YASKAWA AC Drive GA700
Supplemental Technical Manual

Modified Contents

Document No.: EZZ024701<2>
Prepared in September 2025

9. Support for JOHB-SMP3 BACnet/IP Communication Protocol <1>

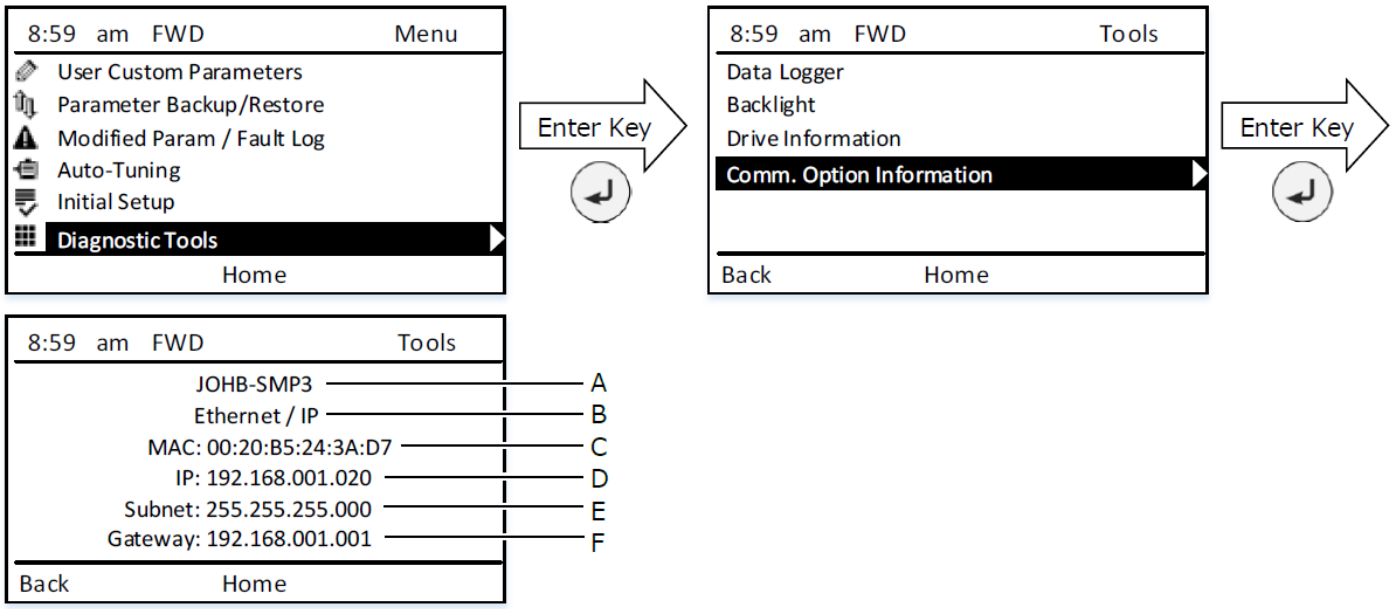
JOHB-SMP3 BACnet/IP communication protocol is now supported. JOHB-SMP3 BACnet/IP communication protocol descriptions have been added to compatible options and related monitors and registers.
(Underlined parts are added items.)
GA700 drives with software version S1038 or later are compatible with JOHB-SMP3 option cards with software version S8207 (BACnet/IP:Ver7001*1) or later.
